Multiple Sewershed Package 16A Solicitation Number: CO-00396-RL Job No.: 20-4506

ADDENDUM 1 March 24, 2021

Multiple Sewershed Package 16A SAWS Job No. 20-4506 Solicitation No. CO-00396-RL

SHEET 59 SECT. No. DR. SRC | CK. JDM | JOB No. 20-4506 | 59 | OF 107

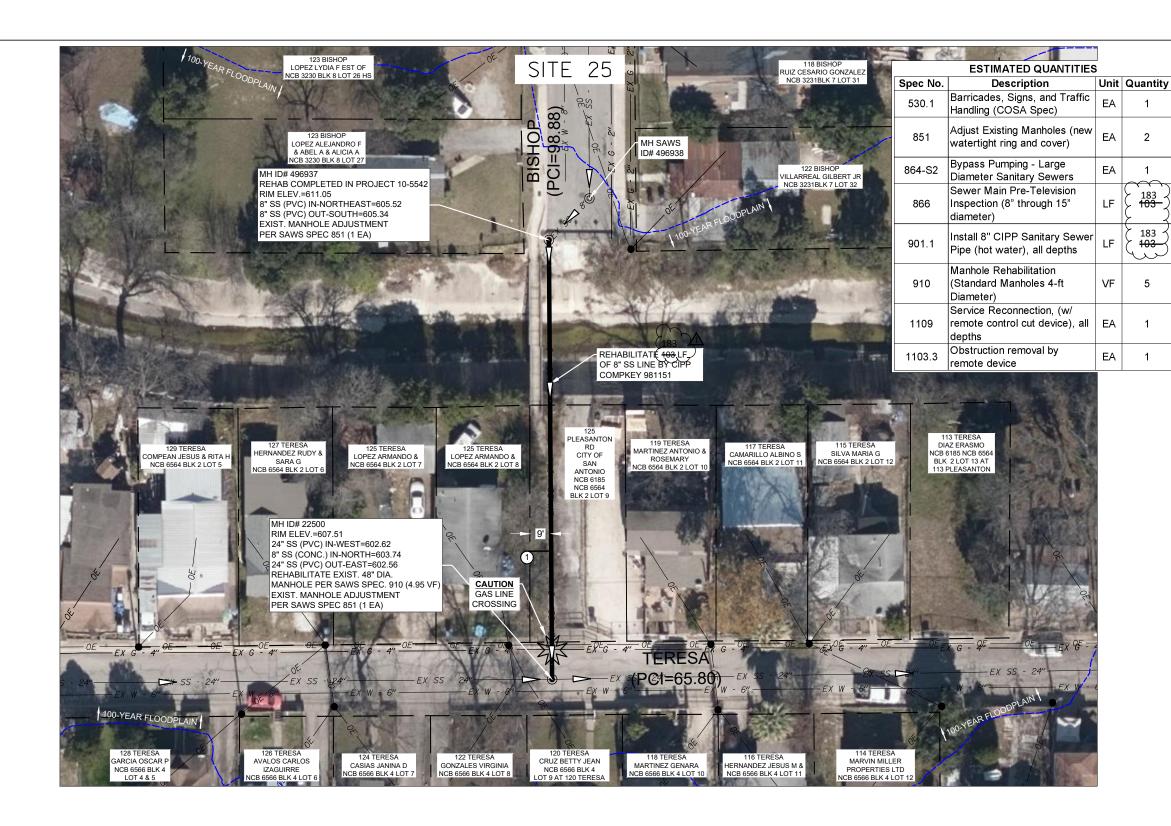
- **1.** Remove Plan Sheet 3 in its entirety and replace it with the attached **Plan Sheet 3**. Below is a summary of the revisions:
 - a. Note 2 of the COSA Floodplain and ROW Notes is revised to update the contact phone number.
 - b. Note 3 of the Bypass Pumping Notes is revised to update the specification item.
 - c. Note 6 is added to the Bypass Pumping Notes.
- 2. Remove Plan Sheet 59 in its entirety and replace it with the attached **Plan Sheet 59**. The revised drawing corrects a typo to the length of the sewer main and associated bid item quantities.

1 REVISED LENGTH JDM 3/3/21 Drawn Approved Date REVISIONS
